CITY OF WICHITA

Wichita-Sedgwick County Metropolitan Area Planning Department

Re: **BZA2026-00026:** Administrative Adjustments in the City to reduce the southeast compatibility setback from 15 feet to 2.5 feet including a reduction of the corresponding street side setback from 5 feet to 2.5 feet (50 percent) for construction of a trash enclosure on property zoned B Multi-Family Residential District, generally located on the north side of East Pawnee Avenue and within one-block east of South Rock Road (8200 East Pawnee Avenue).

WATERCREST AT CHERRY CREEK TRASH ENCLOSURE

1 **SITE PLAN - ADMINISTRATIVE ADJUSTMENT**
1" = 30'-0"

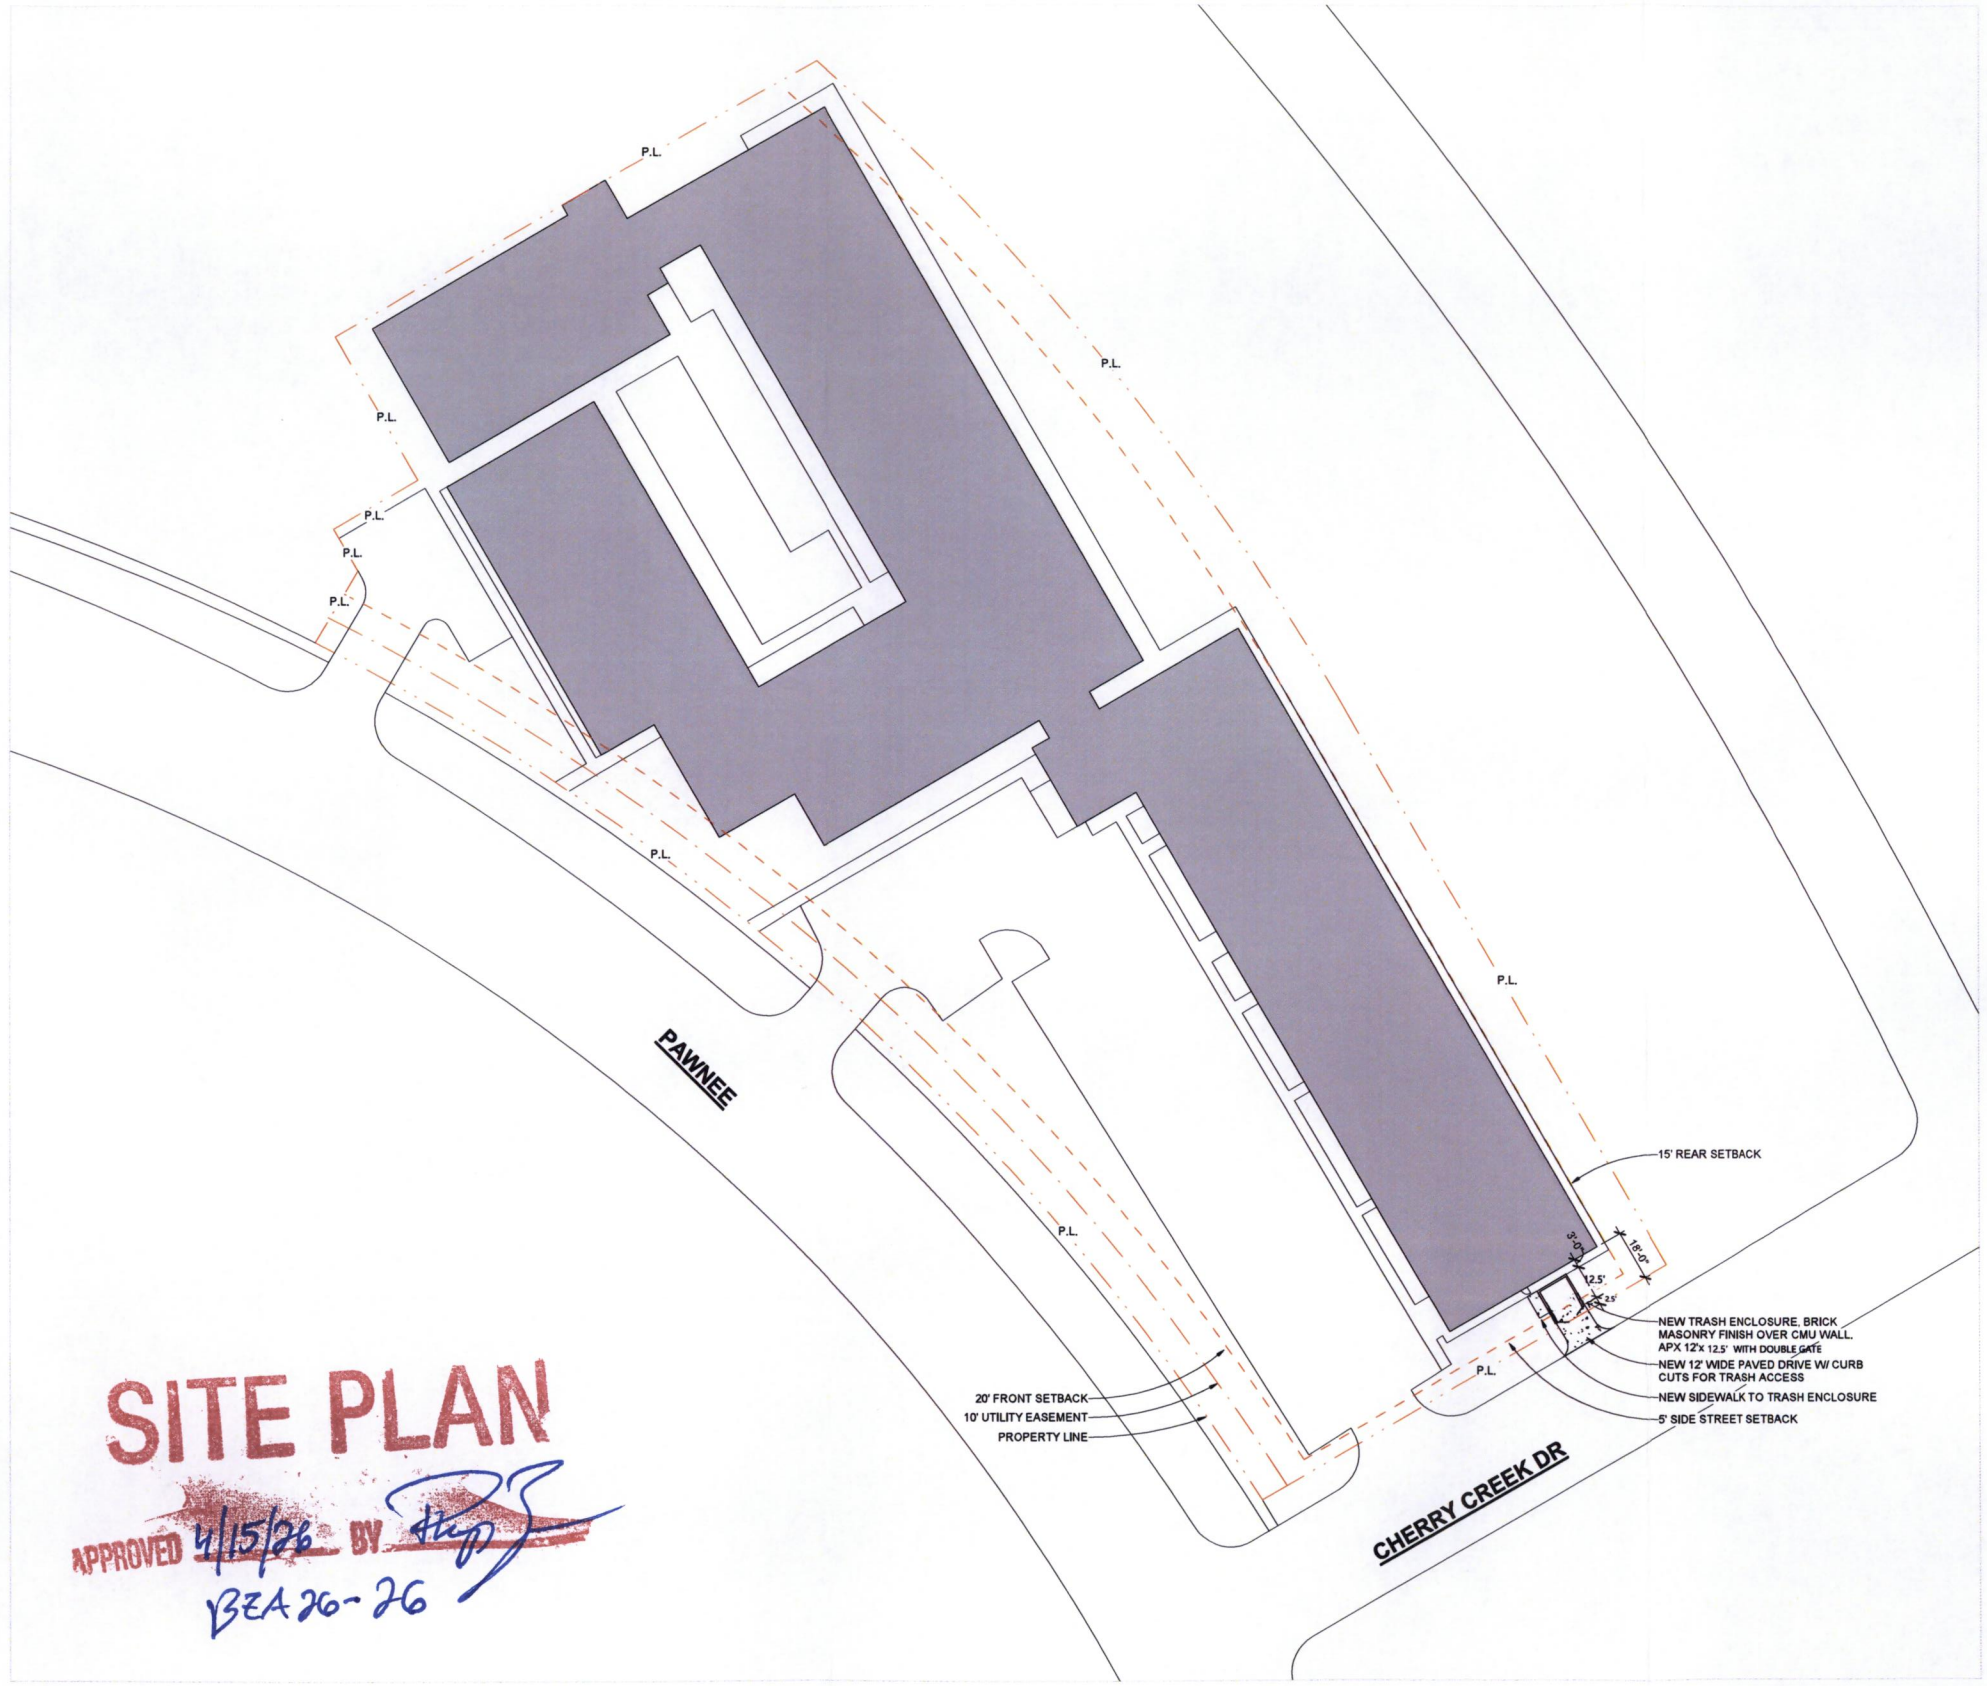
We have reviewed your request for Zoning Adjustments to reduce the southeast compatibility setback from 15 feet to 2.5 feet including a reduction in the corresponding street side setback from 5 feet to 2.5 feet (50 percent) for an area less than 300 square feet on the aforementioned property in order construct a trash enclosure. The site plan indicates the trash enclosure would be on the south side of the eastern-most building. The trash enclosure would provide 3 feet of separation from the building and is proposed to be 12.5 feet by 12.5 feet. The total area of encroachment would be 25 square feet.

Section IV-C.4 of the Unified Zoning Code ("UZC") requires a 15-foot compatibility setback along the side lot line when adjacent to property zoned TF-3 or more restrictive. Properties to the east, across East Cherry Creek Drive are zoned TF-3 and developed with duplexes. In order to reduce the standard building setback from 5 feet to 2.5 feet as described above, a reduction in the compatibility setback is required as well.

Section V-I.2.a of the UZC allows reducing the minimum street side setback (required by the property development standards of the zoning district) by up to 50 percent (for an area less than 300 square feet). Section V-I.2.d of the UZC allows reducing or waiving the required compatibility setback. These adjustments are permissible when the provisions of this section and the Zoning Adjustment Criteria of Section V-I.6 are met. We find that the reduction of the compatibility and building setbacks as proposed meet the provisions of Section V-I.2.a and the four criteria required by Section V-1.6 as set out below:

1) Impact on safety and convenience of vehicular and pedestrian circulation: The proposed reduction of the compatibility and building setbacks to 2.5 feet will have no impact on the safety and convenience of vehicular and pedestrian circulation in the right-of-way. Wichita Traffic Engineering approves of the driveway location.

2) Impact on existing uses in surrounding areas: There will be no impact on the existing uses. The surrounding properties on the north and east are zoned TF-3 and developed with a mixture of single-family dwellings and duplexes. Properties to the south and west are zoned B Multi-Family. Property to the west is part of the larger subject site. Property to the south is developed with an apartment complex. The small scale of the structure and encroachment is not likely to have significant detrimental impacts on nearby properties.

3) Compatibility with existing or permitted uses on abutting sites: The proposed trash enclosure's location makes for easy access for trash collection vehicles from East Cherry Creek Street.

4) Effect on public health, safety, or welfare: There will be no negative impact on the public health, safety, or welfare, nor will properties or improvements in the vicinity be materially injured.

Our signatures below indicate that the Zoning Adjustments to reduce the southeast compatibility setback from 15 feet to 2.5 feet and the corresponding street side setback from 5 feet to 2.5 feet for an area less than 300 square feet are hereby GRANTED, subject to the following conditions:

1) The site shall be developed in general conformance with the approved site plan.

2) The applicant shall obtain a building permit within one year of the Administrative Adjustment approval. The site shall conform to all codes including but not limited to zoning, building, health, and fire.

3) The setback reduction shall apply only to the 2.5-foot southeast street side setback as illustrated on the approved site plan. All other structures or additions on the subject property shall conform to the setbacks permitted by the Unified Zoning Code unless a separate Zoning Adjustment or Variance is granted.
